# Oregon Engineering School Design

## PACIFIC VIEW DESIGN TEAM

# Mentor feedback on Proposal 4

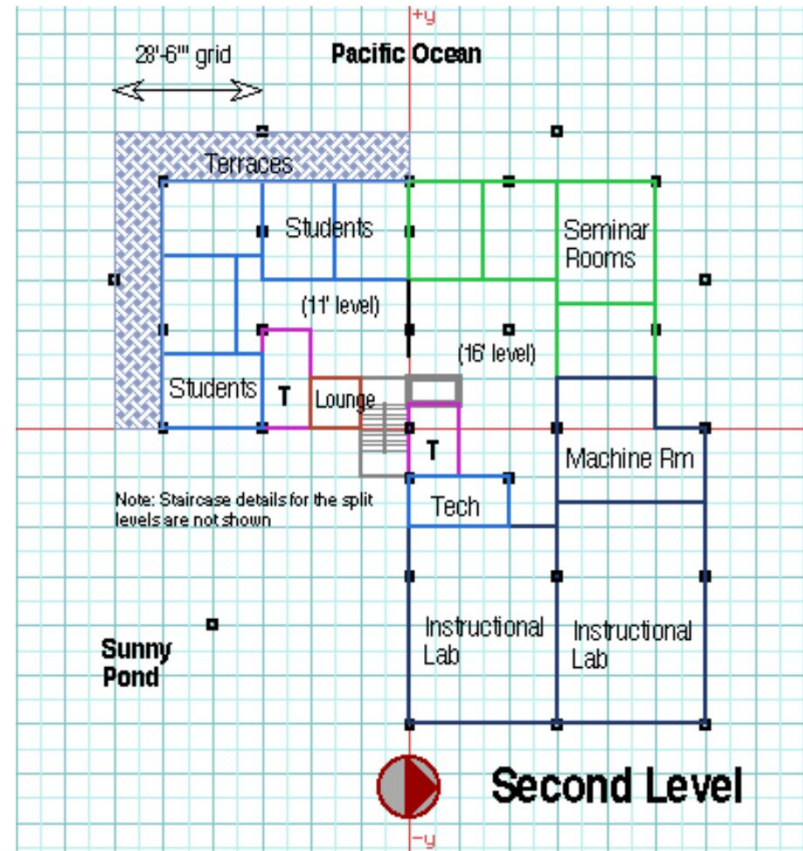
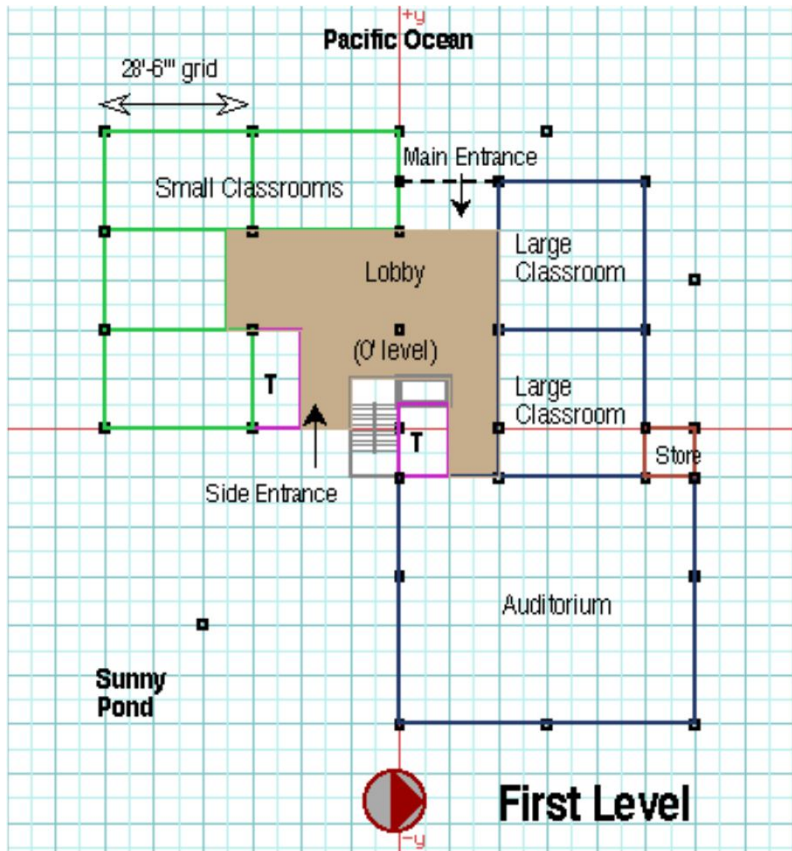
- Circulation pattern was not well defined
- Overabundance of terraces
- Three seminar rooms had no natural lighting
- Toilets did not align vertically
- Too many wall offsets at third level
- Support the third floor cantilever by a vertical column going into the pond.
- Have some variation in the building section

# Problems in Iteration 1

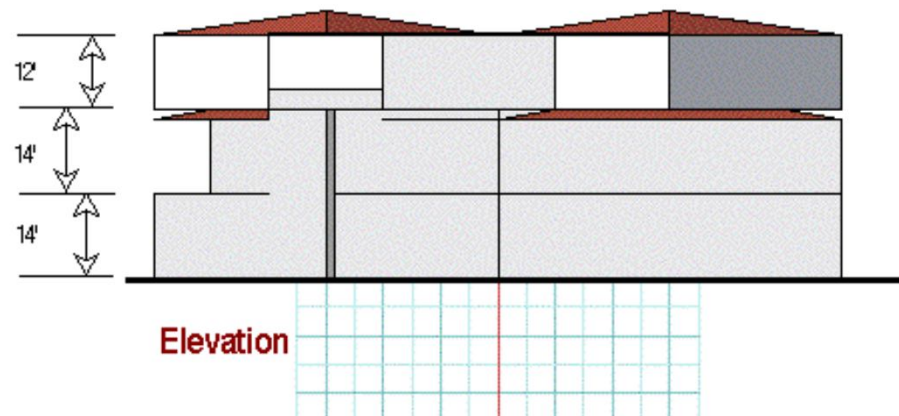
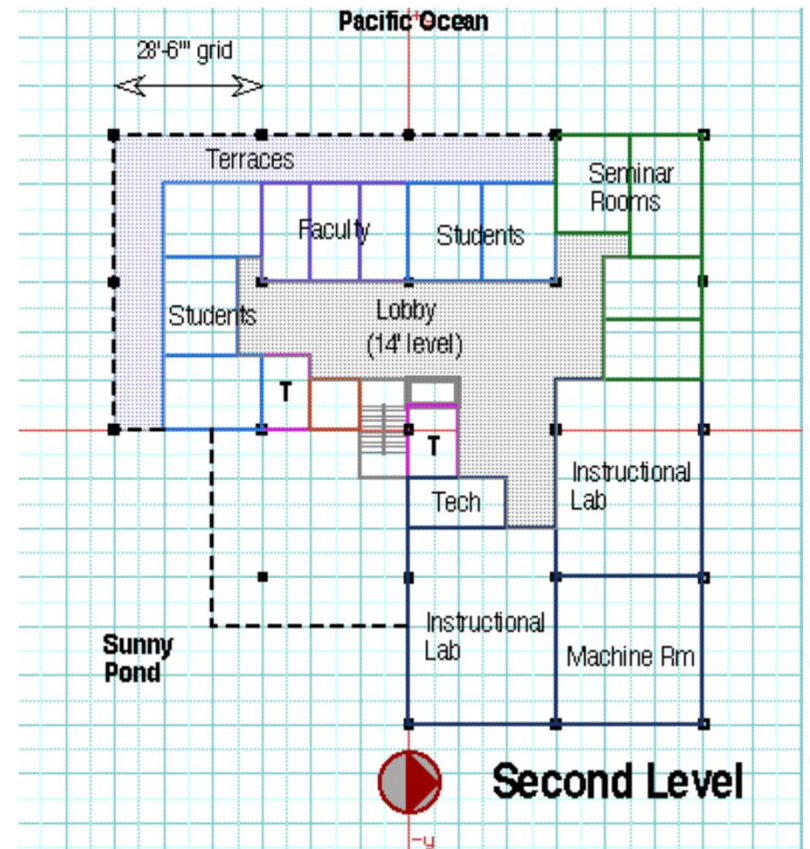
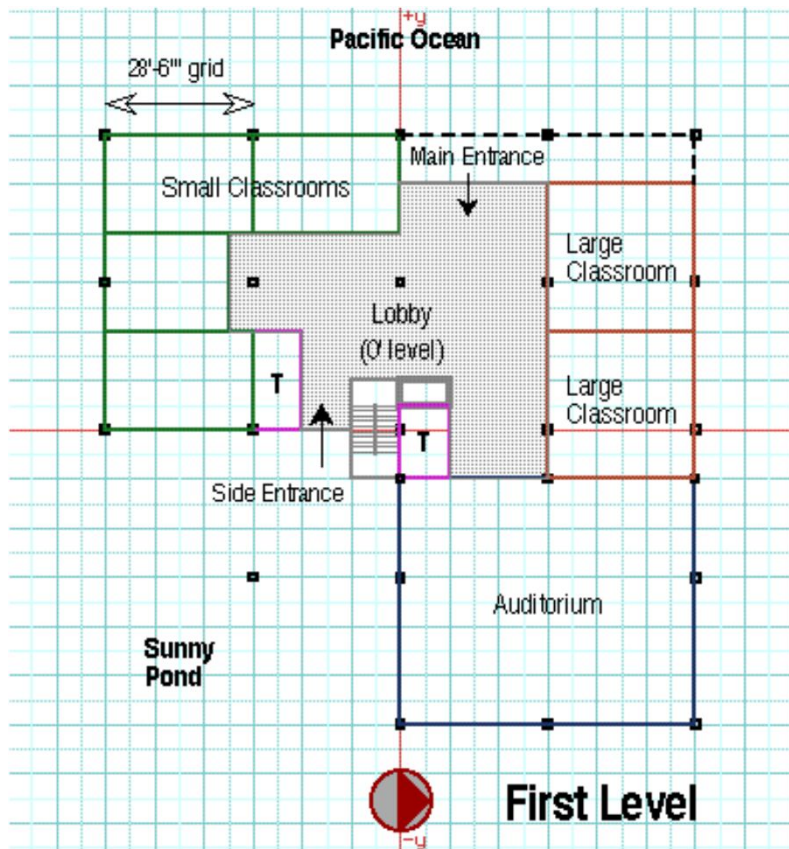
- Non uniform structural grid
- Many columns lacking vertical continuity
- 10' height for a level was insufficient for HVAC system
- Sloping roofs at the second level did not seem very well composed
